CONTRACT CHANGE ORDER No. 170
SHEET ___ OF ___

ROADWAY LEVEL WESTBOUND
LIGHTING AND ELECTRICAL SYSTEMS
SCALE: 1:200

EE-26

ROADWAY LIGHTING POLE PLAN LOCATION-SHEET 17
SKYWAY STRUCTURES
NO SCALE

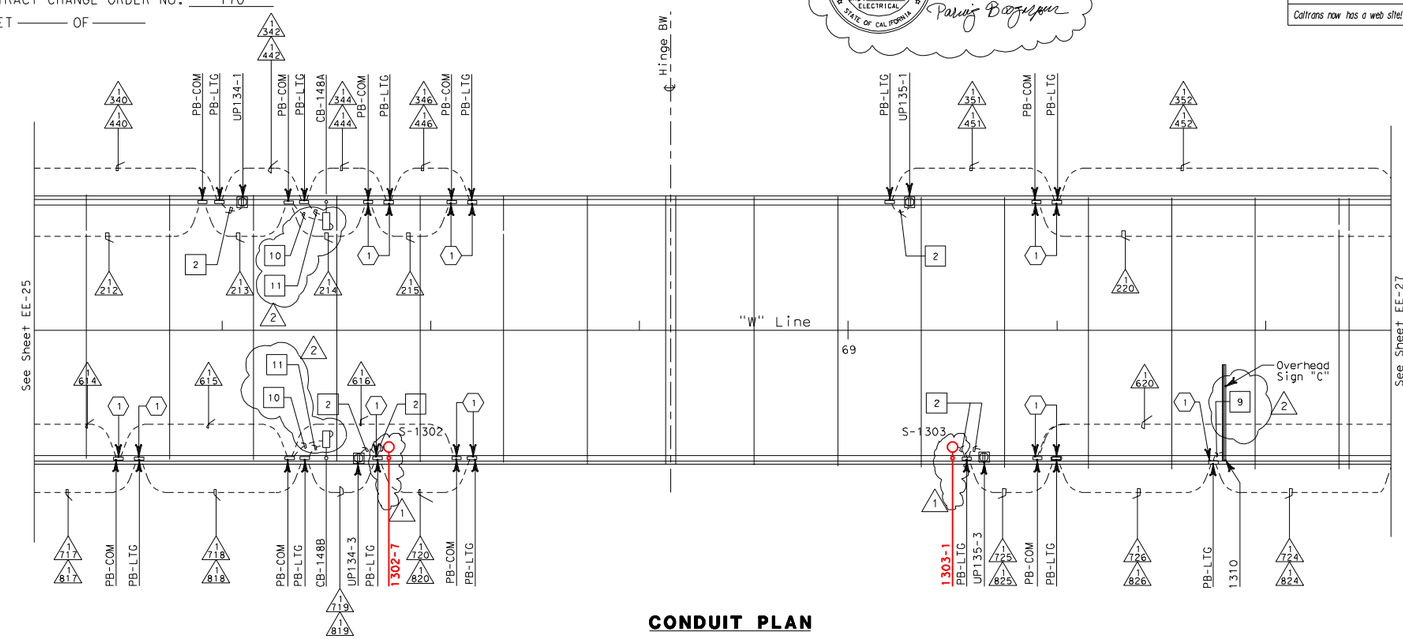
MARK	DATE	DESCRIPTIONS	REV	CK	
2	1/20/06	Delete CB-148A & CB-148B. Coil 5 m of call box signal and power cable in adjacent PB-COM and PB-LTG pull boxes. Coil and tape 10 m of 3/C #6+G (9) in adjacent PB-LTG.	JE	EJL	CCO No. 170
1	3/2/05	Delete Roadway light poles and fixtures. Coil 10m, 3#10 conductors in the pull box adjacent to light pole locations.	RS	PB	CCO No. 123
